**RE: Daniel's HVAC
8308 Washington St. NE, Albuquerque, NM 87113
Grading and Drainage Plan (C17D125)
Engineers Stamp Date 9/19/2022**

TITLE: Daniels HVAC
8308 Washington St. NE
Grading & Drainage Plan

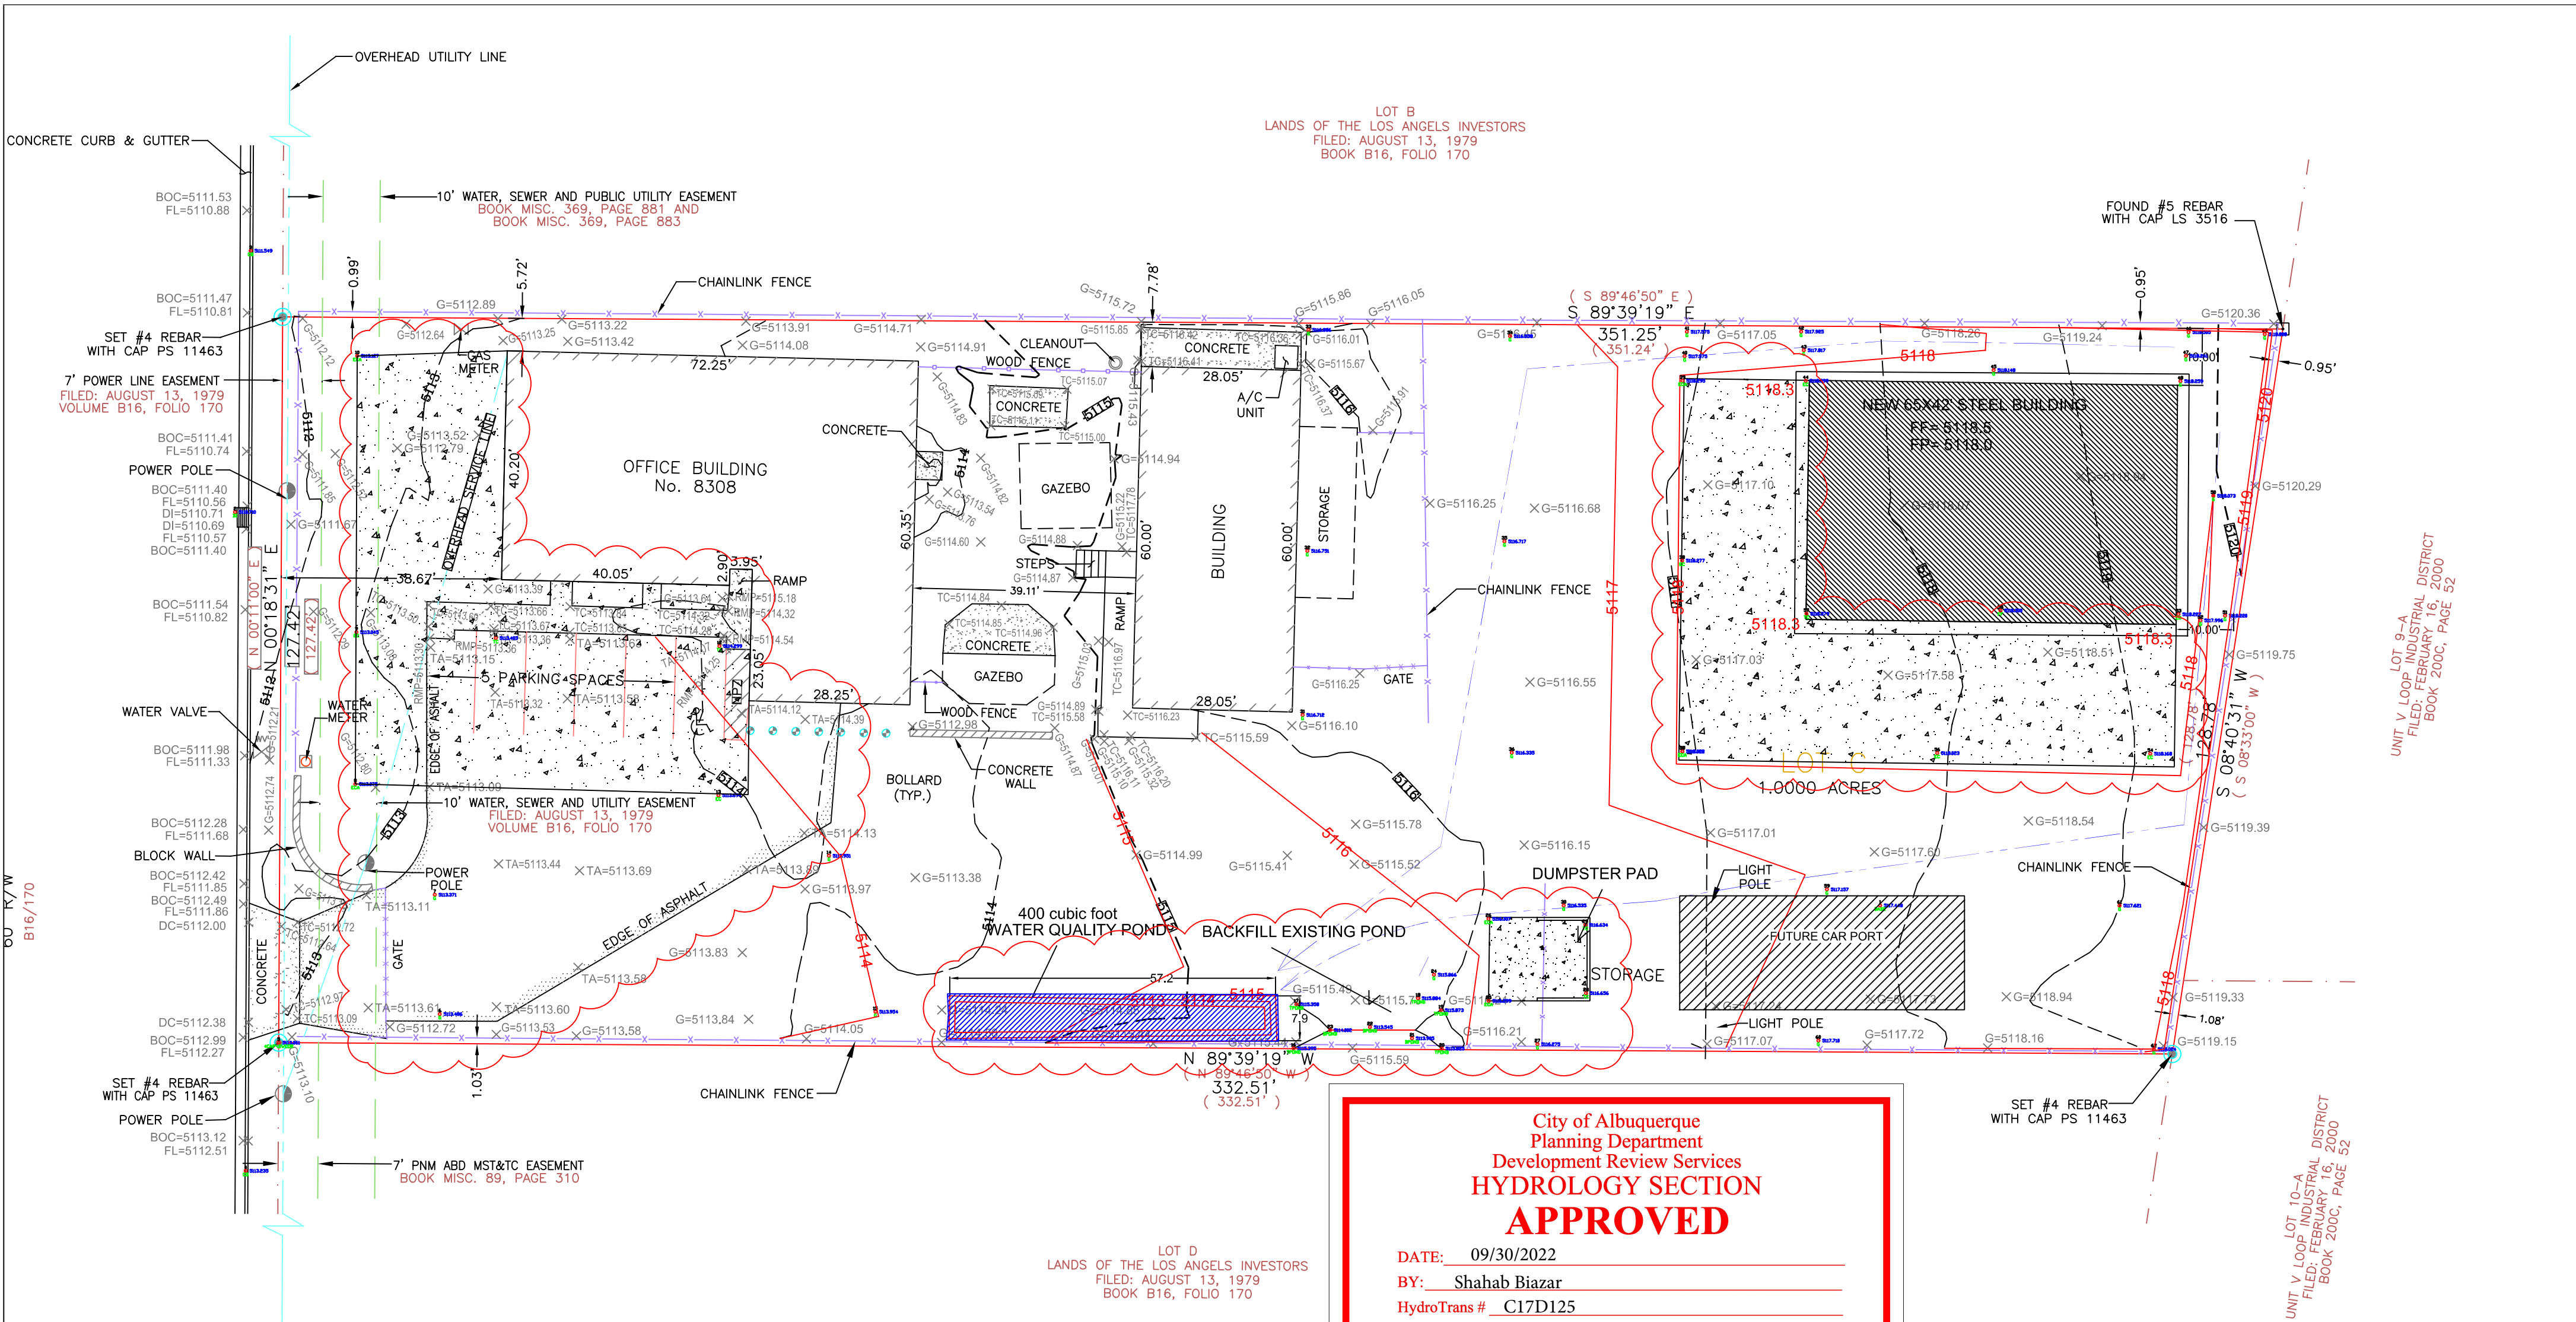
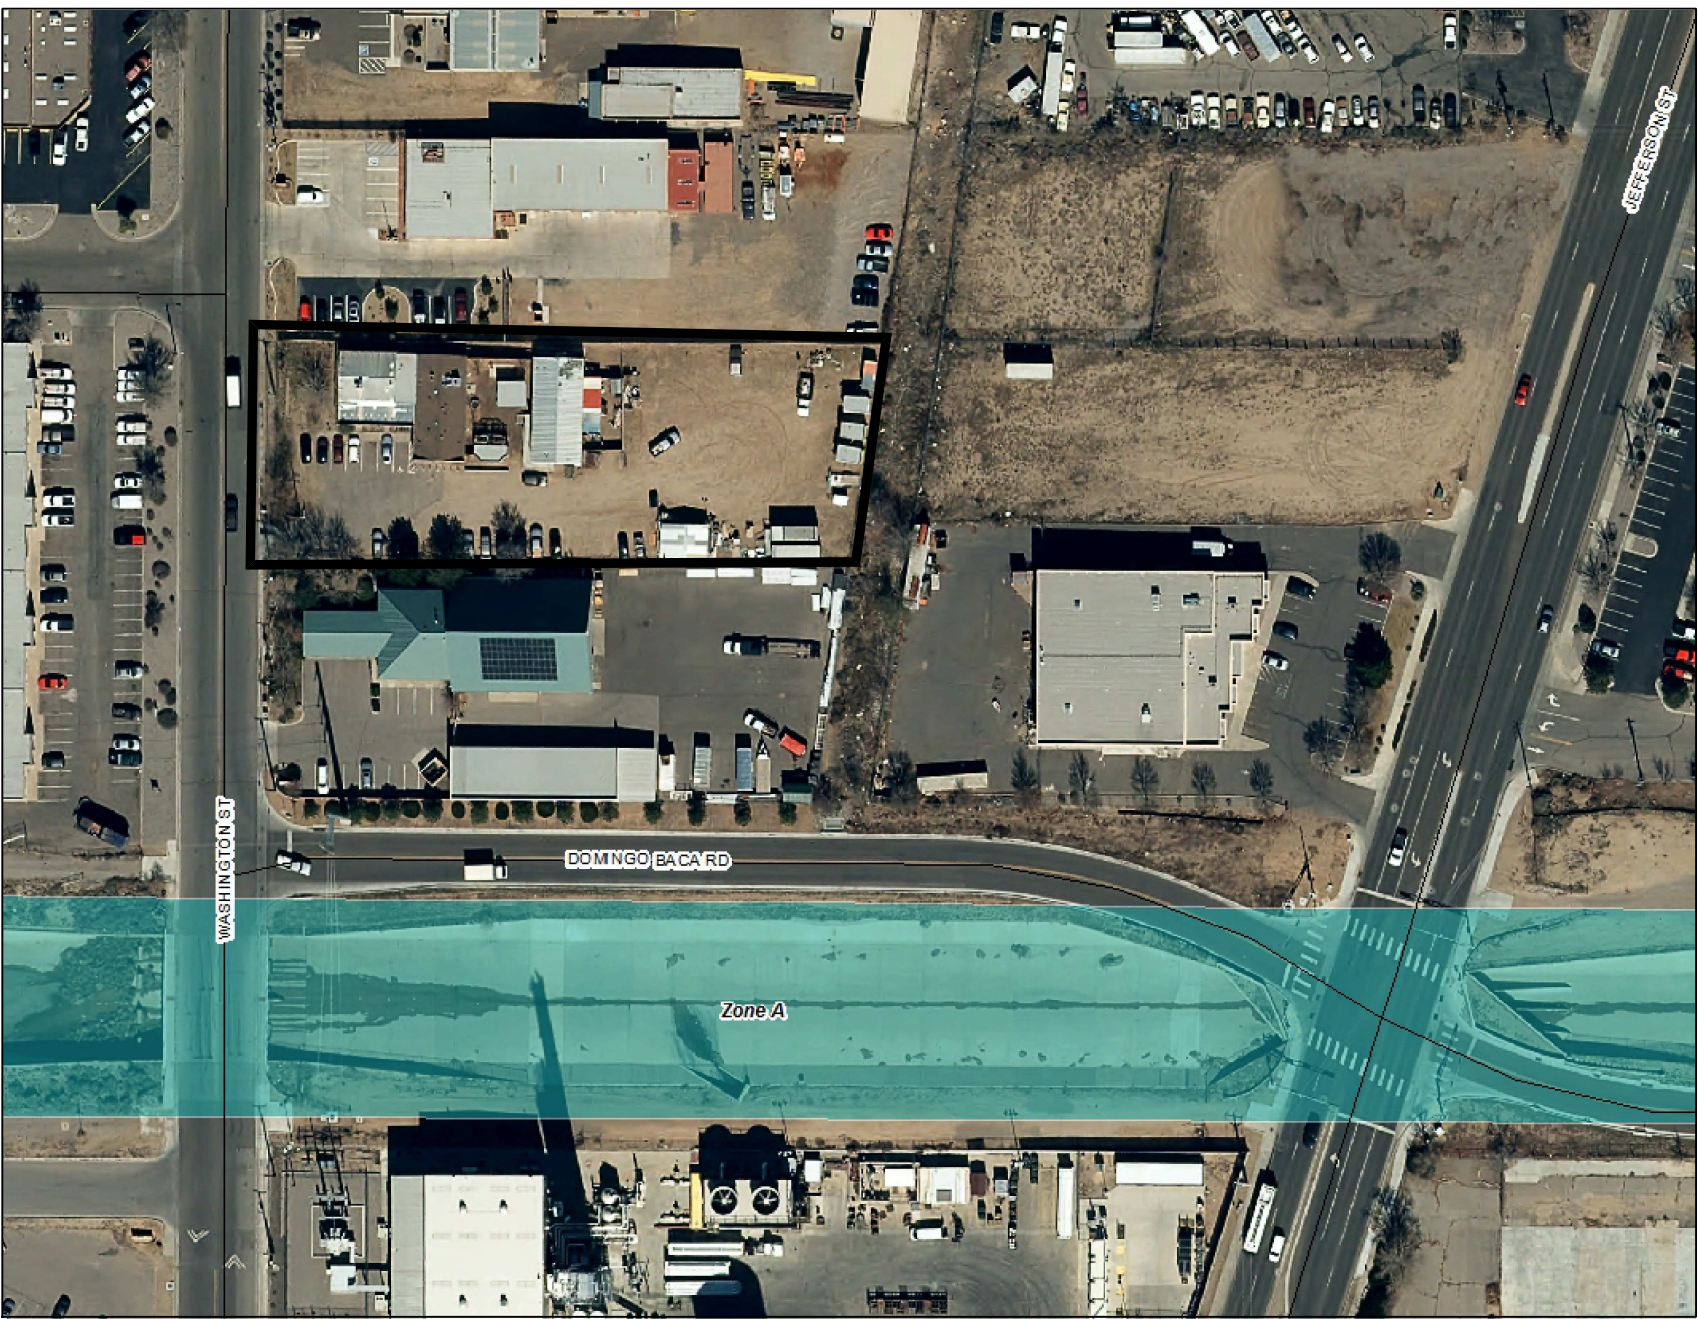
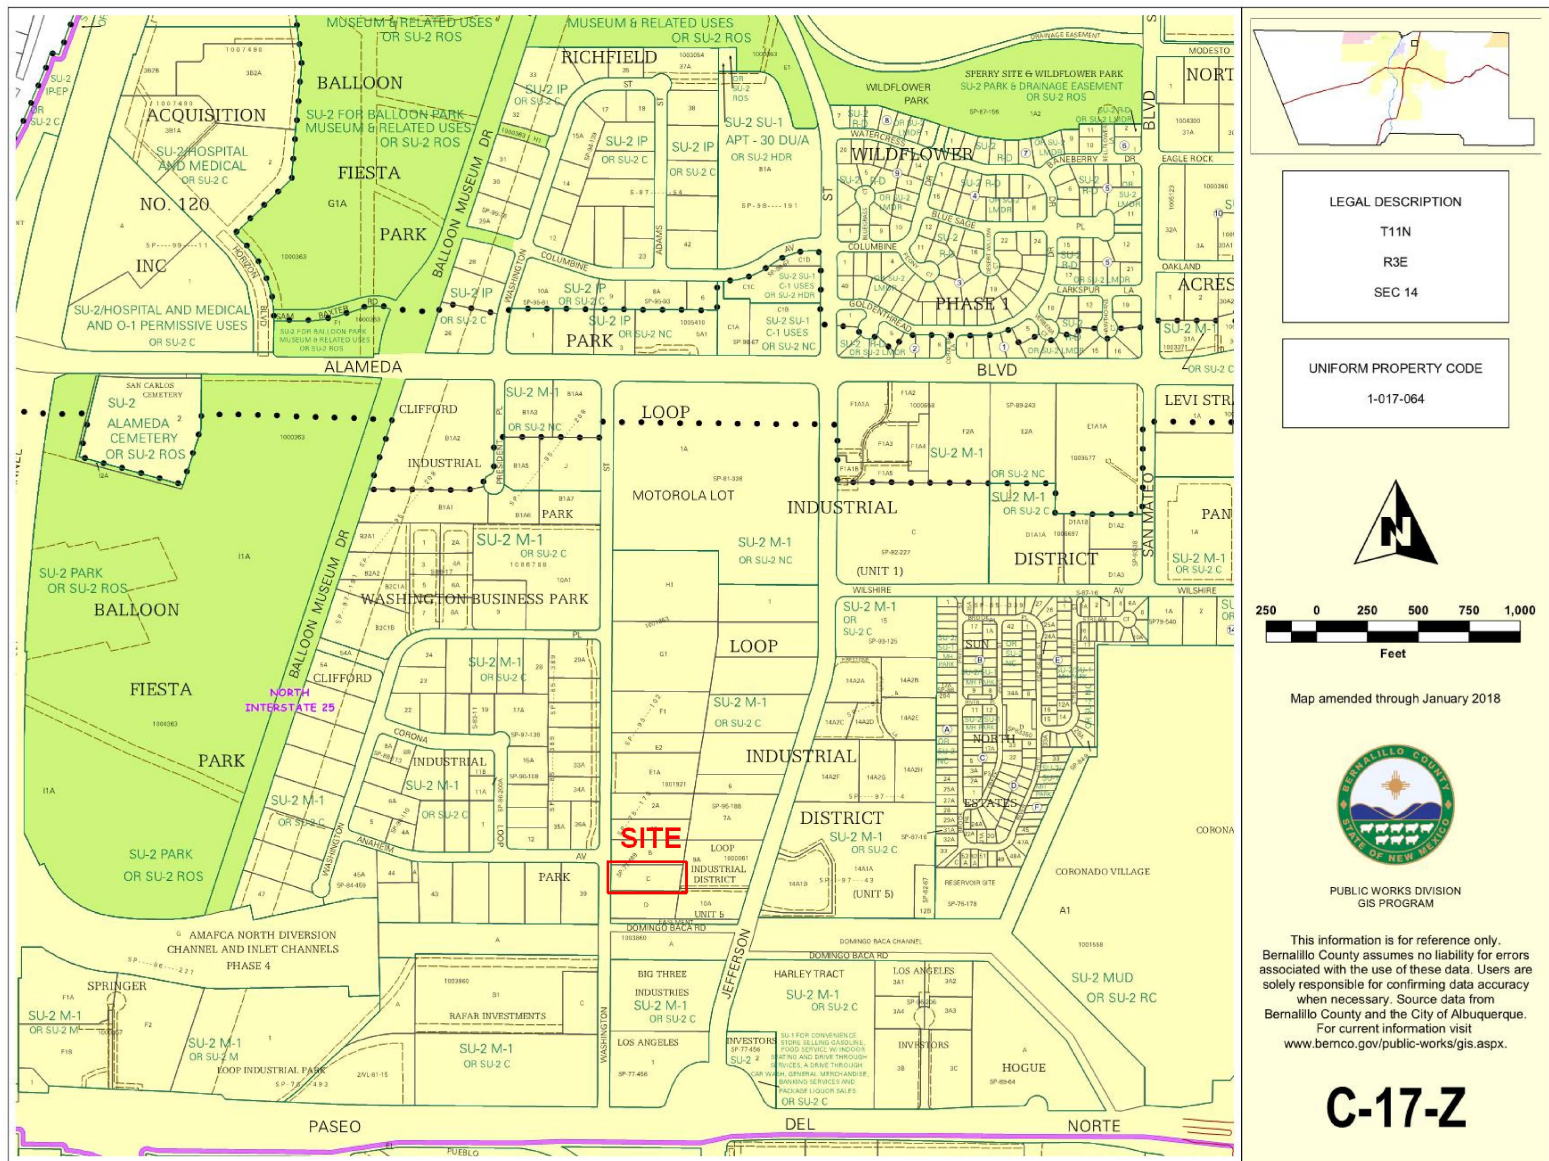
Based upon the information provided in your submittal the plan is approved for Building Permit. The following item will be required prior to Certification of Occupancy:

1. Engineer's Certification, per the DPM Part 6-14 (F): *Engineer's Certification Checklist For Non-Subdivision* is required.

2. Please provide the Drainage Covenant with Exhibit A for the stormwater quality ponds per Article 6-15(C) of the DPM prior to Permanent Release of Occupancy. Please submit the original copies along with the \$ 25.00 recording fee check made payable to Bernalillo County to Carrie Compton (cacompton@cabq.gov) on the 4th floor of Plaza de Sol.
